**Heather Lands Parcel B - 620 W 35th Ave
DP-2024-00802 – CD-1 (pending)**

DEVELOPMENT PERMIT STAFF COMMITTEE RECOMMENDATION: APPROVE

THAT the Board APPROVE Development Application No. DP-2024-00802 submitted, the plans and information forming a part thereof, thereby permitting the development of three buildings on this site consisting of a 24-storey apartment (B1) with 207 strata units and 67 moderate income rental units, a 20-storey apartment (B2) with building with 203 strata units and 2 secured market rental units and a 12-storey apartment (B3) with 101 secured market rental units and 32 moderate income rental units, subject to the following conditions and approval of enactment and form of development:

Figure 5: Building Heights and Massing Comparison between Rezoning (left) and DP (right)

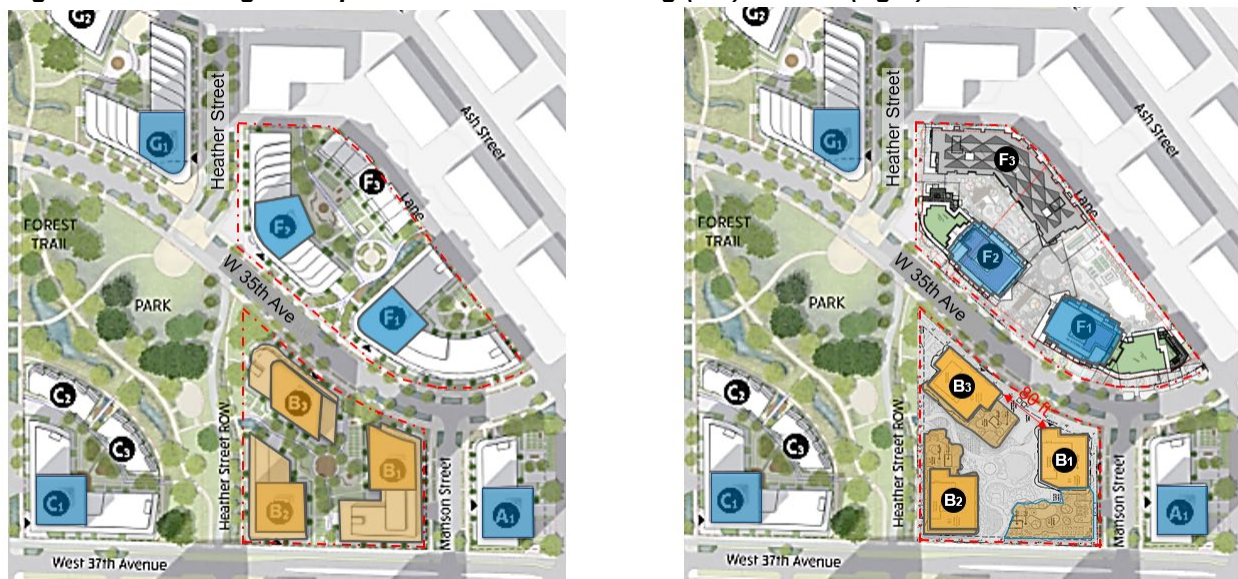
a) Reduction in podium heights and massing

The Guidelines envision podium heights of 6 and 7 storeys, however partial 8th storeys were proposed at buildings B1 and B2.

Staff is supportive of a simpler building form by minimizing terraces and shoulder setbacks to achieve more efficient and sustainable buildings. Elimination of the partial 8 storey of the B1 and B2 podiums is supported. Although the B1 podium is 7 storeys high, it does not increase shadowing of the courtyard or public open space. Landscape treatments to reduce the scale of the podium along W 35th Ave are recommended in Recommended condition 1.1.

The development permit application proposes a 6-storey podium for buildings B2 and B3, and a 7-storey podium for B1 (see *Figure 5*, right). The podiums were reduced in footprint and shaped to increase the size of the interior courtyard and maximize solar access.

Figure 7: Comparison between Rezoning (Left) and DP (Right)

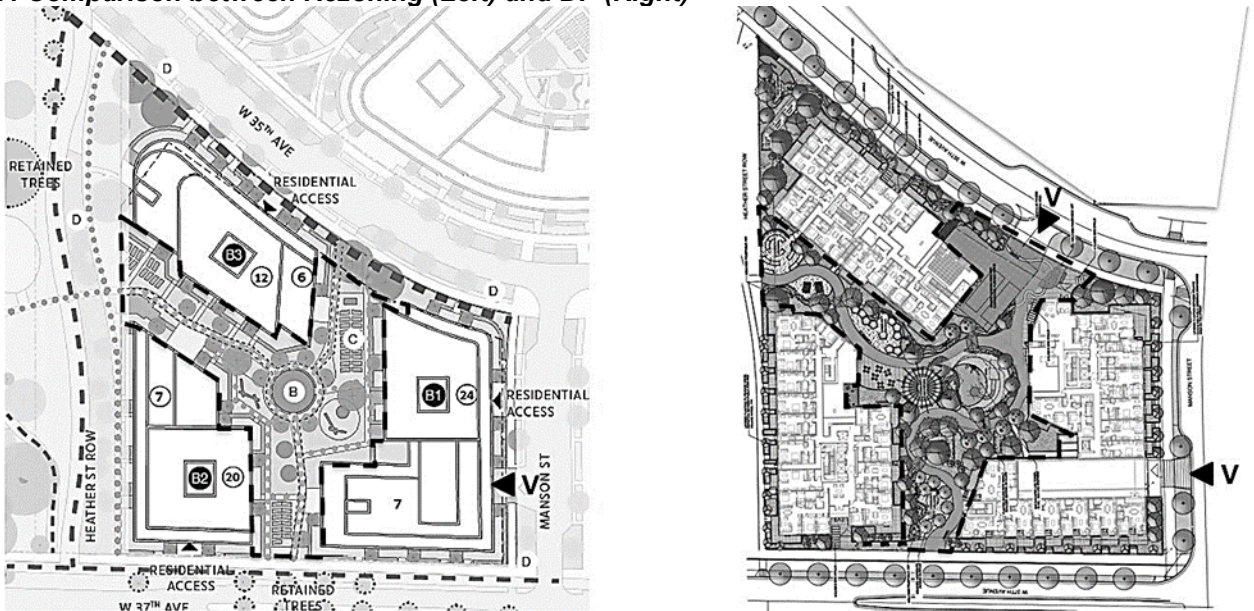
The Guidelines envision one vehicular entry point on Manson St, with garbage, recycling and loading located below grade (See Left).

The application proposes a new vehicular site entry and surface loading off W 35th Ave (See Right).

The additional vehicular entry and surface loading are not supported. Staff strongly recommend adhering to the concept approved at rezoning. Staff have included a condition to consider replacing the garbage/recycling area with ground floor amenity space, to better activate adjacent open spaces, including the public realm along W 35th Ave as per Recommended condition 1.1.

Condition 1.1 and A.2.7.i requires redesign of the vehicle and loading access points into the site, to provide a single driveway crossing on Manson St.
